Zoning By-Law Amendment

Lots 76, 77, 78 & 79, Caswell & Clements Survey, Town of Minto,

401, 411, 417 & 423 Jane Street

Site Plan and Jane Street Development Agreement

Site Plan A6837 (September 2017):

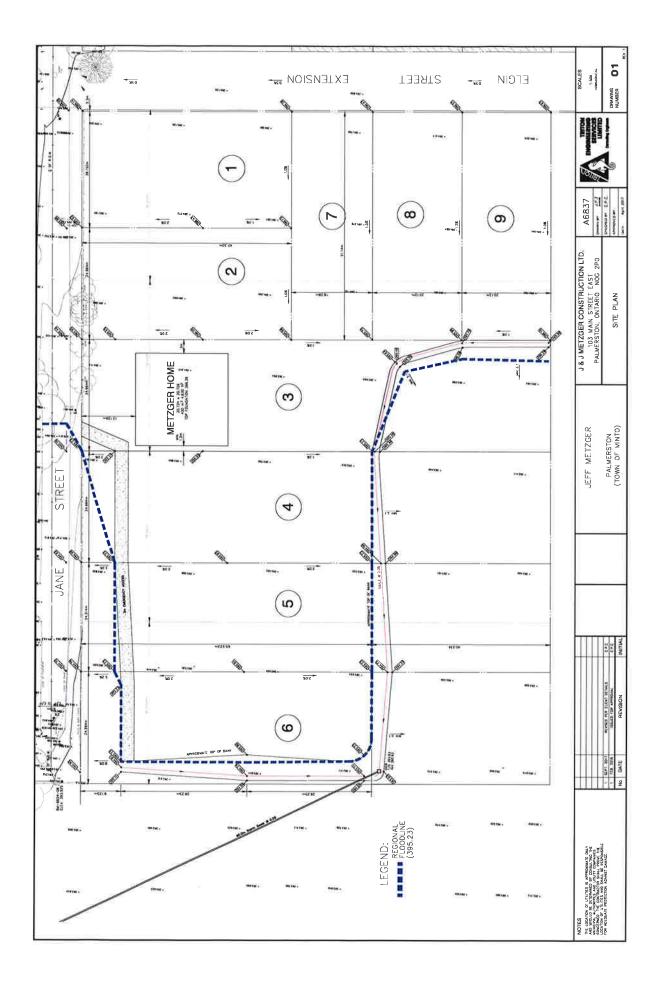
The grading plan shows less fill than originally proposed in Triton Engineering's Jane Street Floodline Impact Assessment (September, 6, 2016). As such, we are satisfied the impact to the floodplain elevation is less than originally proposed, which was concluded by Triton and our peer reviewer to not be significant. The finished grades of lots 1 to 9 are above the floodplain. As such floodproofing future residences is feasible.

We are further satisfied that the grading plan demonstrates safe ingress and egress to an area outside of the floodplain. New structures proposed on lots 3 to 6 should be located South the 3 metre emergency access.

1. A condition should be included to ensure all structures on lots 3 to 6 do not encroach onto the 3 metre wide emergency access.
